# **Keystone RV Company**

# **SAFETY ADVISORY # 19-341**

# Montana 3854BR/3855BR Slide Rams

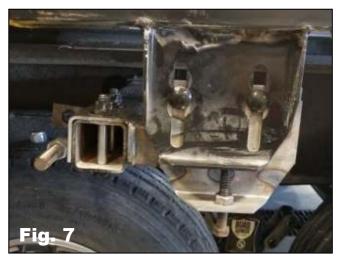
If there is less than 2 3/4" of space between the adjustment head and tire replace the head with the part number provided above. See Figure 1 for incorrect head. Replace the adjustment head mechanism with an offset adjustment head using the following steps.

- 1. Extend the dinette slide room out about half way.
- 2. Remove the fender and skirt metal and fender skirt support as shown in Figure 3.

- 3. Remove nut on the end of the hydraulic ram, use a backup wrench or vise grips to prevent the ram from turning.
- 4. Support the weight of the slide room using a jack, taking care not to damage the slide room floor.

- 5. Remove the head assembly from the end of the inner arm assembly and remove the first lag in the room bar to the right of the inner arm. Transfer the adjustment bolt to the new head assembly. The adjustment bracket is attached to the room bar and will remain there until the next step. See Figure 4.
- 6. Carefully using a Sawzall with a metal blade, cut off the adjustment bracket from the room bar. Cut it right at the room bar as it will be needed for later use. See Figure 4.
- 7. Attach the adjustment bracket to the KRV # 628594 Mechanism Drop Head Assembly 2 1/2" x 2 1/2" Adjustable w/Gussets Powder Coated Black

and set in place on the inner arm assembly as seen in Figure 5. Insert bolts for the head assembly from bottom to top as seen in Figure 6.

8. Align adjustment bracket with room bar so that it is flush with the outer portion of the room bar. Grind the paint off the room bar and weld the adjustment bracket in place. See Figure 7.
